ATP Handbook

Amendments to paragraph 6 (c) (iii) of Annex 1, Appendix 1 of the ATP Handbook: Rules to be observed for the installation of mounted units, units with deflectors, under-frame units or units that can be offset

Transmitted by the Government of France

Case No. 1: Standard production vans with integrated insulation and unit partially recessed in the roof:

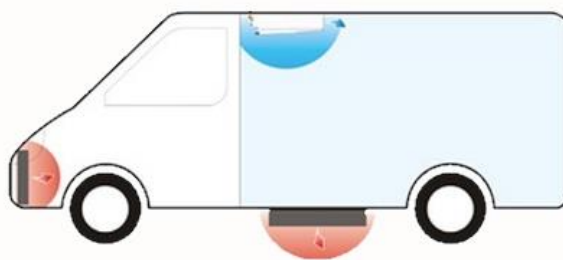
Provisions to be applied for fitting recessed thermal appliances**Case No. 1**

The installation instructions must specify that:

- A minimum distance must be maintained between the walls of the recessed drip basin and the air inlet of the condenser;
- A maximum depth of the drip basin must be ensured. The drip basin must not be deeper than the maximum height of the unit's condenser.
